## CHAPTER 4.0: REVISIONS TO THE DRAFT SEIR

This chapter contains the revisions to the Draft SEIR. Text that has been deleted from the draft document is shown ~~with a red line through the deleted text~~. Text that has been added is shown with **bold red type**. The locations of the revisions are indicated by the headings, subheadings, paragraph numbers, page numbers, or other reference to assist the reader in locating the changes in the Draft SEIR. Where a revision is in response to a comment, it has been noted.

Figure 4. 12-3A Noise and Vibration Mitigation for Tunnel Portion

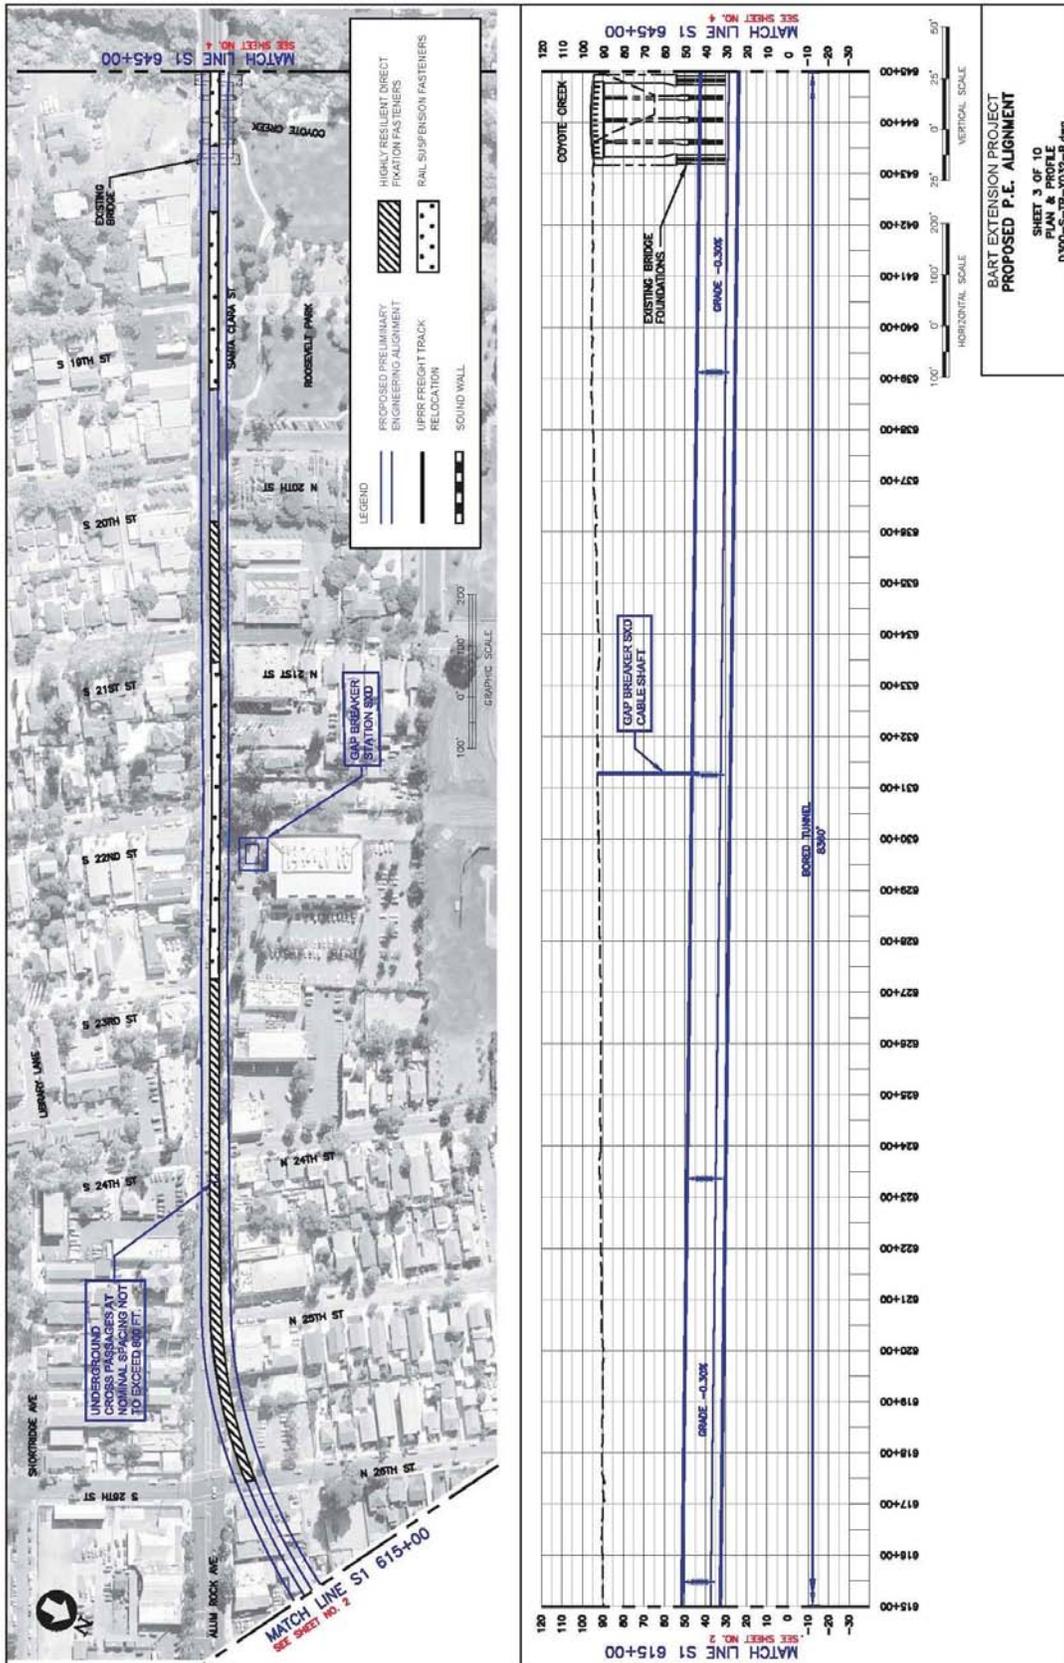
Section 4.12.4.2 *Tunnel Segment Groundborne Noise and Vibration Impacts*, Figures 4.12-3a and 4.12-3b on pages 166 and 167 have been deleted and replaced with the following two figures.

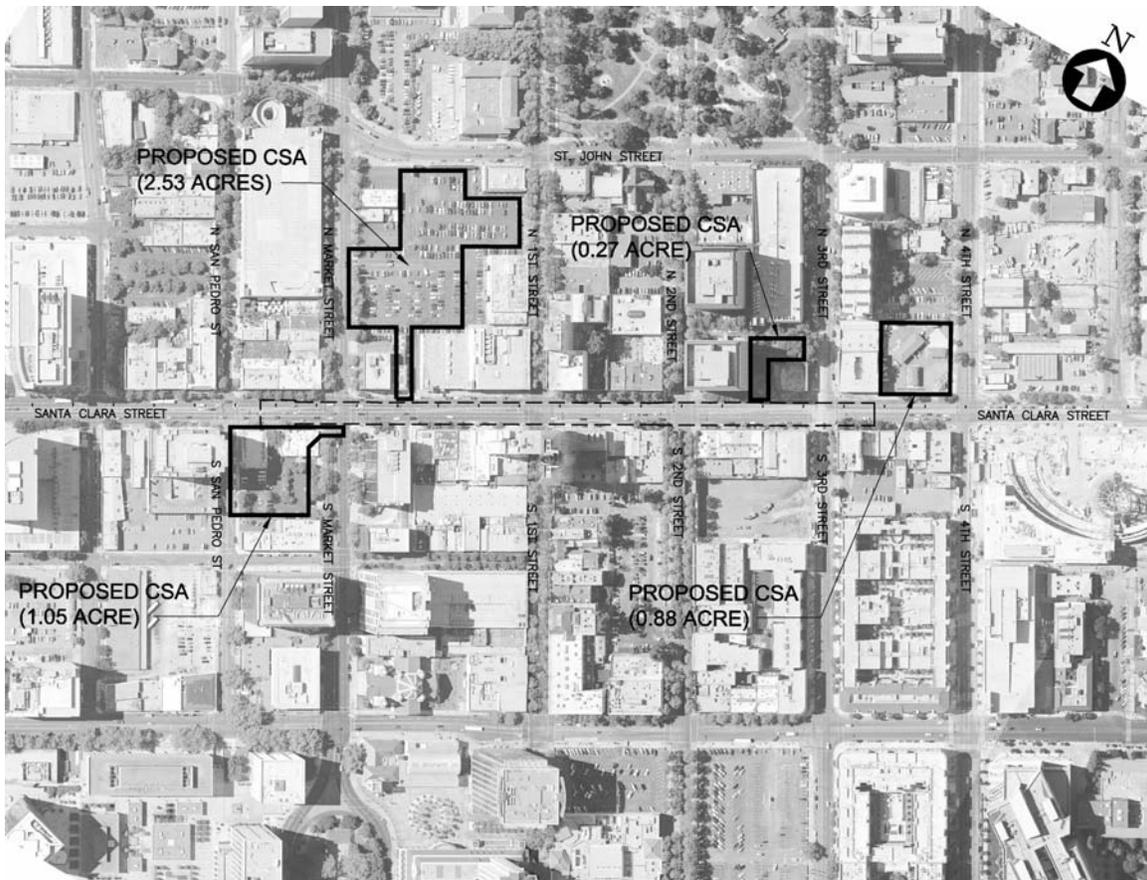
Section 4.18.4, Construction Staging Areas, 9<sup>th</sup> bullet, and page 245, Figure 4.18-35 have been revised:

**The Downtown San Jose CSA has been reduced in size by approximately 1/3 acre, from 2.88 acres as shown in the Draft SEIR to 2.53 acres. This results in the retention of street access and approximately 40 dedicated parking spaces adjacent to several buildings in the block of properties between Market Street and First Street on the northern side of Santa Clara Street.**
